**Town of Surfside  
PLANNING & ZONING BOARD  
AGENDA**

**FEBRUARY 24, 2022 – 6:00 p.m.**

##### **A. 9165 Collins Avenue – Site Plan Approval**

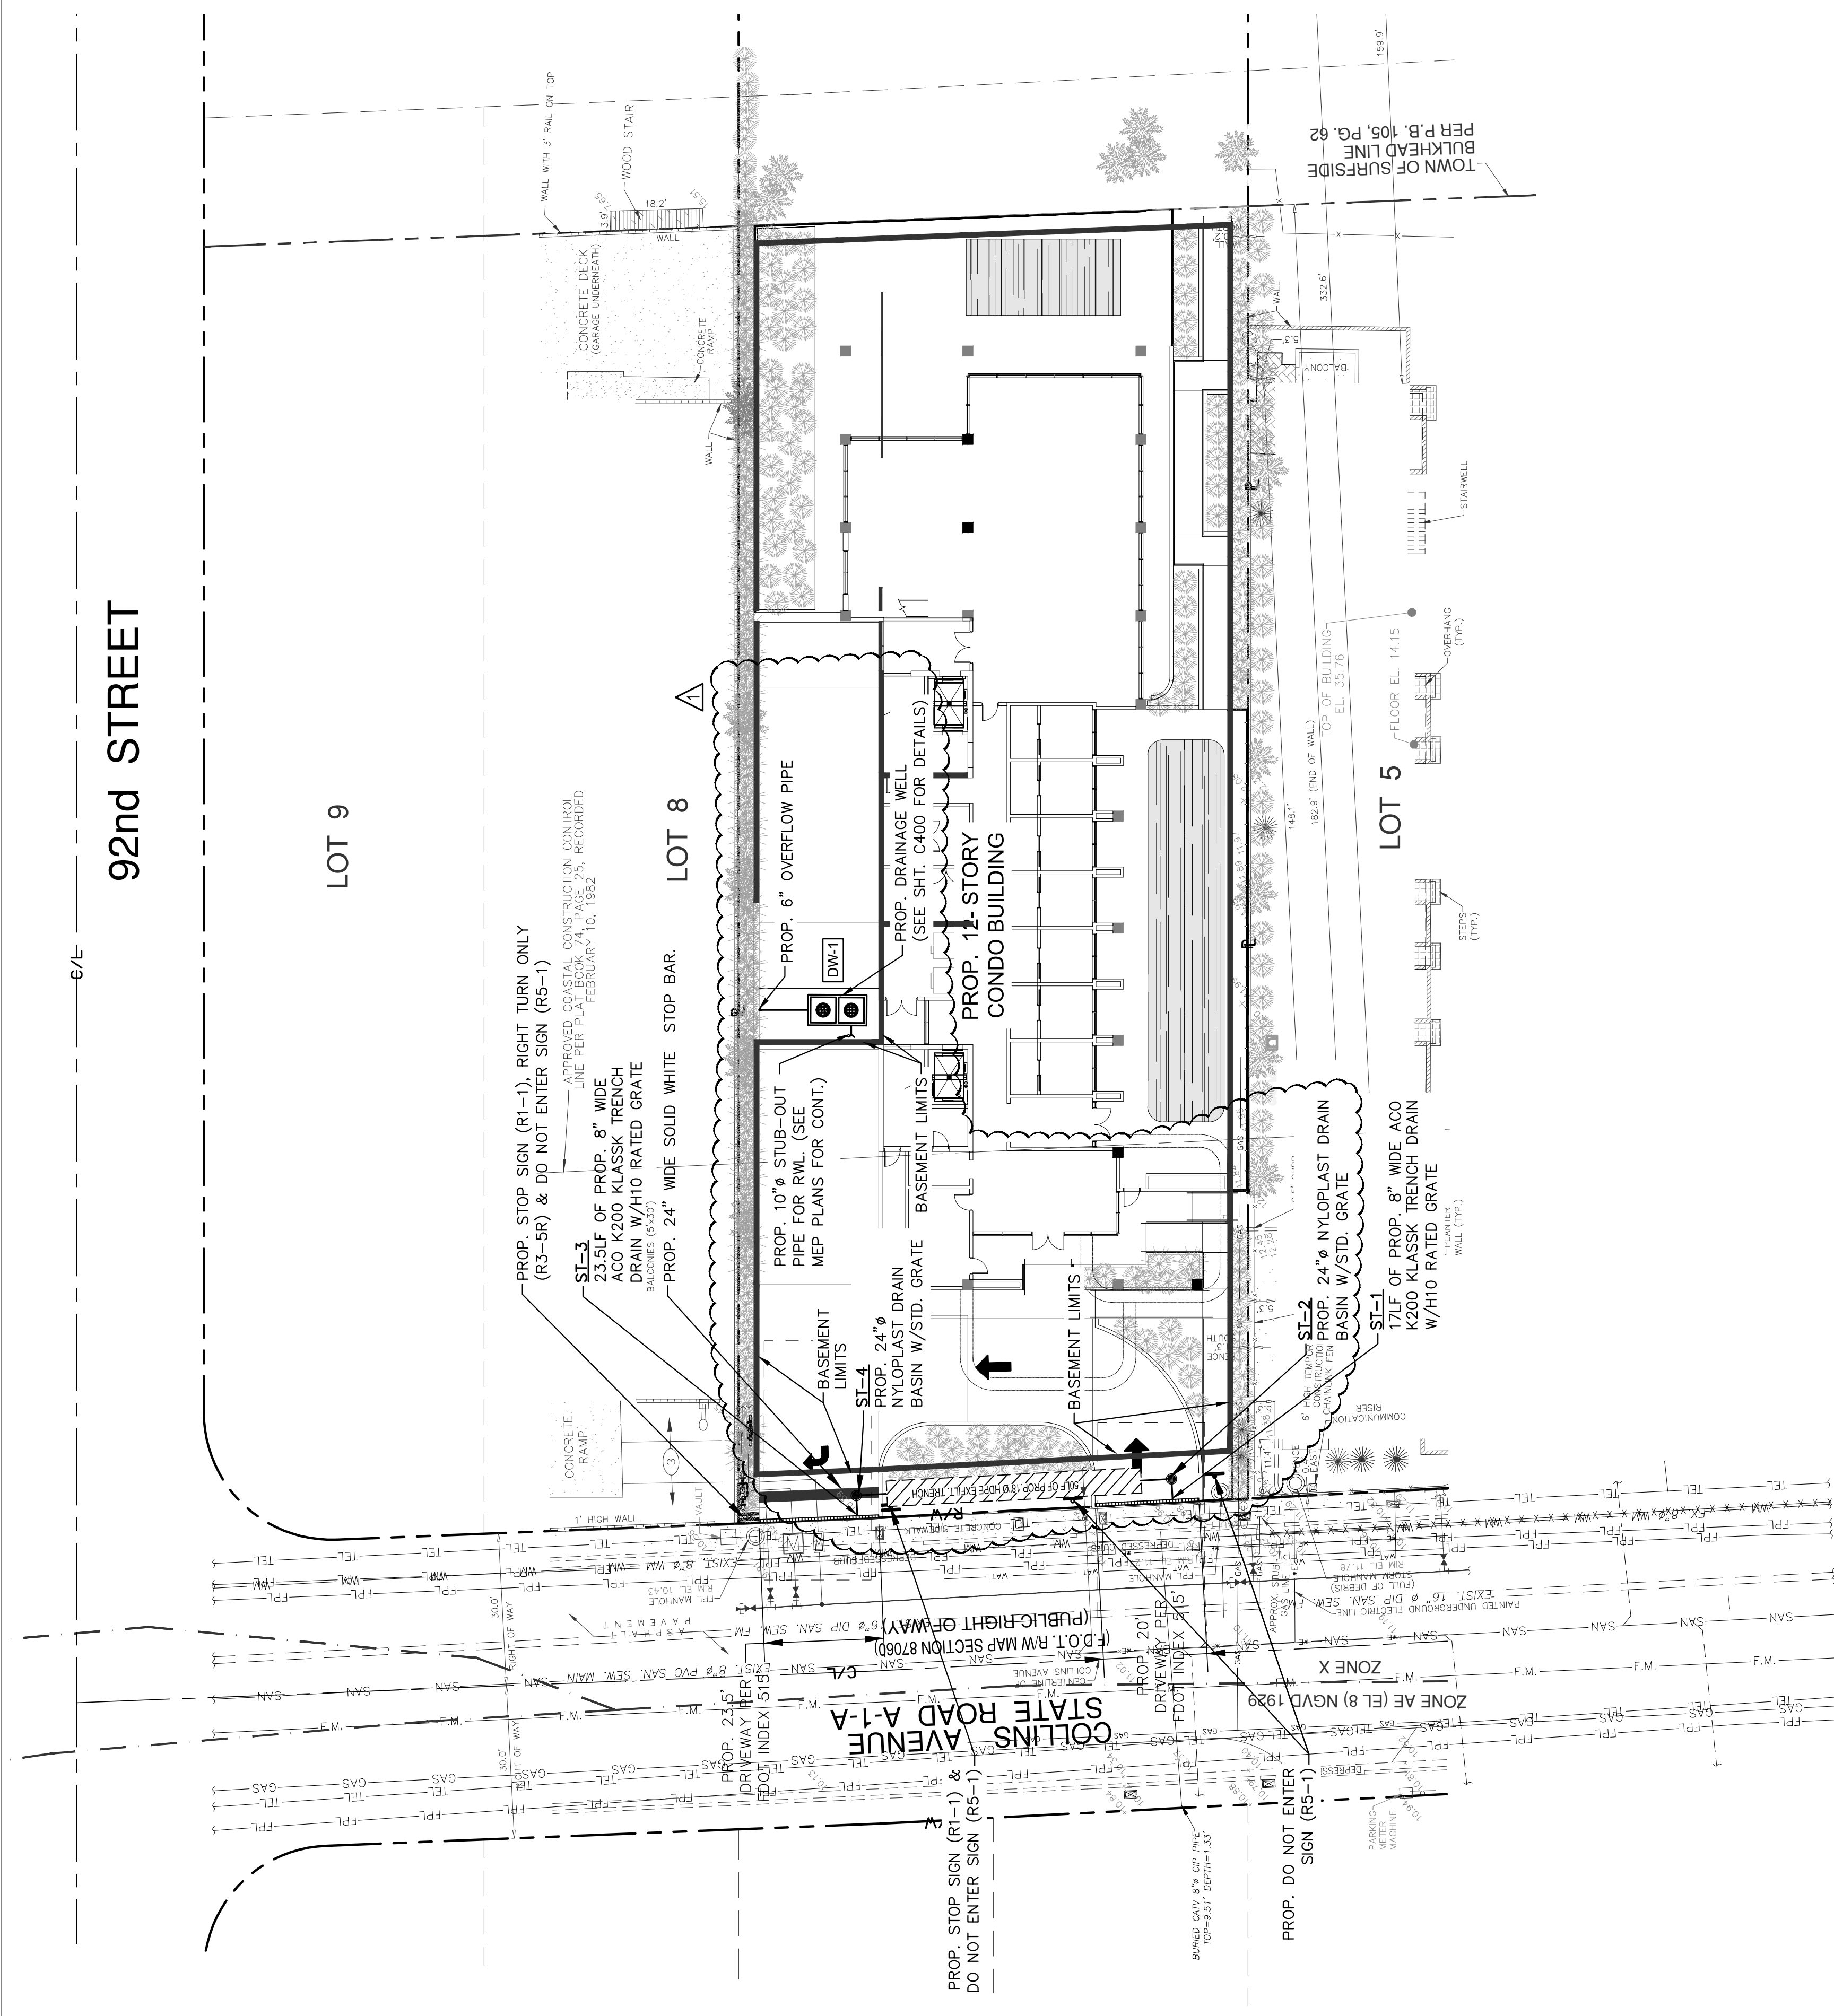
A landscape review was performed. Differences were noted between the Architectural Site Plan (Sheet A3.00) and the Landscape Site Plan (L-100). Pervious area requirements for H120 are 20% and 25.6% is provided with the majority of the previous area occurring in the private recreation area east of the Bulkhead Line. The landscape plan utilizes the landscape treatment provided by the Seaway project on the south side of the property. The landscape plans did not include the required irrigation plan. Dimensions of the landscape buffers need to be provided between properties. A landscape calculation table needs to be provided indicating the minimum required and provided comparisons of the proposed plant material. Provide percentages of landscaping in VUA, street lengths, buffer lengths, percentages of Florida Friendly material and native/drought tolerance material. Proposed Green Buttonwood trees exceeds 30% of the same species and should be reduced in number. Oleander can be used as an accent but does not qualify as a required tree or Palm. The percentage of required trees being proposed as Palm trees should be provided.
